UNITED STATES
DEPARTMENT OF THE INTERIOR
BUREAU OF LAND MANAGEMENTFORM APPROVED
OMB NO. 1004-0135
Expires: July 31, 2010**SUNDRY NOTICES AND REPORTS ON WELLS**
Do not use this form for proposals to drill or to re-enter an abandoned well. Use form 3160-3 (APD) for such proposals.

CHEVRON USA INC REQUESTS TO MAKE A CHANGE TO APPROVED SUNDRY EC # 293096 APPROVED ON 03/20/2015 BY CHRIS WALLS. CHEVRON PLANS TO BATCH DRILL ONLY SURFACE CASING. THE INTERMEDIATE AND PRODUCTION CASING WILL NOT BE BATCH DRILLED. PLEASE SEE ATTACHED BATCH DRILL INFORMATION.

**Delaware Basin
Changes to APD for Federal Well**

Summary of Changes to APD Submission

Batch Drilling Sequence

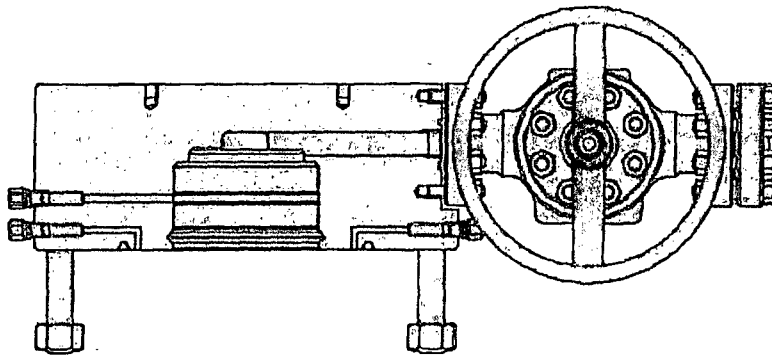
Summary: Variance to batch drill the Salado Draw pad not requested in original submittal.

As Defined in APD:

Variance to batch drill not requested.

As Planned on Well:

Chevron respectfully request the ability to batch drill in the **SALADO DRAW 29 26 33 PAD**. The summary provided is a brief description of the main operational sequences for drilling and casing the four wells listed.

Original COAs still stand.
Operator shall ensure wellbore is secure prior to drilling the next surface hole
